# HITACHI SEMICONDUCTOR TECHNICAL UPDATE

Classification of Production	MCU			No	TN-SH7-402B/E	
THEME	Information about bug with FDIV on SH7055RF		Classification of Information	1. Spec change 2. Supplement of Documents ③ Limitation of Use	4. Change of Mask 5. Change of Production Line	
PRODUCT NAME	SH7055RF	Lot No.	Reference Documents	SH-2E Programming Manual Rev.1.0 ADE-602-178	Rev.	Effective Date
		SH7055RF :ALL lots			2.0	Unlimited

Fig1. Example 1 about bug with FDIV

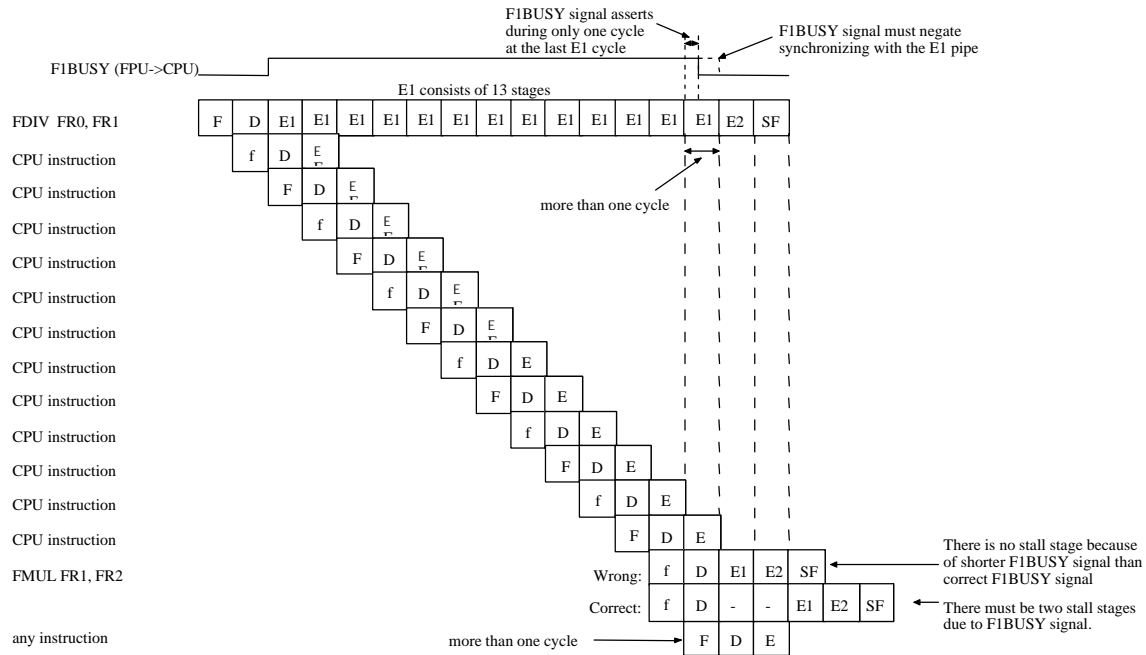
In this example, FDIV operates FR1/FR0 -> FR1, and then FMUL at the 13<sup>th</sup> instruction after FDIV operates FR1 x FR2 -> FR2. If the number of the fetch cycle of the next instruction of FMUL is more than one cycle, the number of the last E1 cycle of FDIV is extended to more than one cycle due to it. So there is no stall stage in FMUL and FMUL uses the FR1 value before FDIV operation, not the FR1 value after FDIV operation. But FDIV operates itself correctly.

As shown in Fig 1 and Fig 2, the F1BUSY signal is the control signal from FPU to CPU, which asserts during E1 stages of FDIV to prevent CPU in the pipe of FPU instruction to proceed during FDIV operation.

Example 1 of Fig 1 is an example of this. There is no this case if the program is located on the internal flash memories and rams.

SH7055RF: We are very sorry that we would like to keep it unchanged. We would like to fix this bug for our successor product. We appreciate your patience.

We prepared a check program which checks if this bug exists in your application under mass production. When an error or a warning message comes out from the check program, the portion where the message comes from needs to be analyzed if this bug occurs at pipeline execution. Please contact us for the check program and pipeline execution analysis.

Hitachi compilers will be modified to output code which will not generate this bug. The schedule and version of the compilers are followings.

Fig2. Example 2 about bug with FDIV

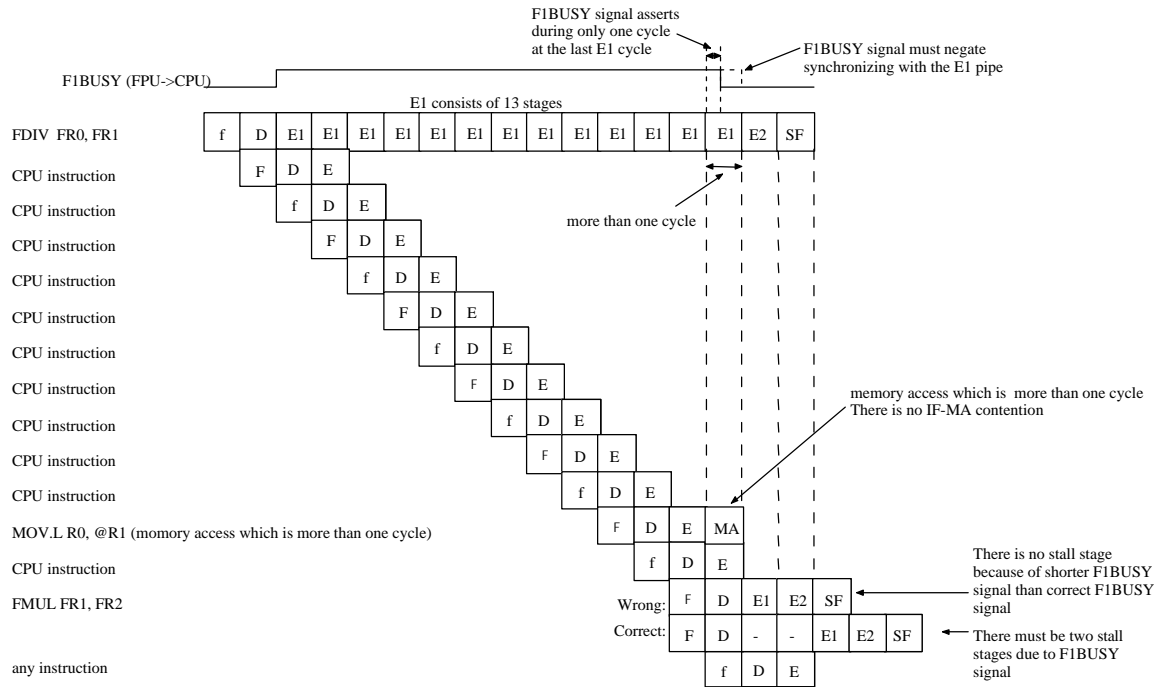
In this example, FDIV operates FR1/FR0 -> FR1, and then FMUL at the 13<sup>th</sup> instruction after FDIV operates FR1 x FR2 -> FR2. If the 2<sup>nd</sup> instruction before FMUL operates memory access which is more than one cycle and there is no IF-MA contention at the memory access, the number of the last E1 cycle of FDIV is extended to more than one cycle due to it. So there is no stall stage in FMUL and FMUL uses the FR1 value before FDIV operation, not the FR1 value after FDIV operation. But FDIV operates itself correctly.

Example 2 of Fig 2 is an example of this. There is no this case if there is no instruction with MA of more than one cycle at one or two instruction before the FPU instruction.
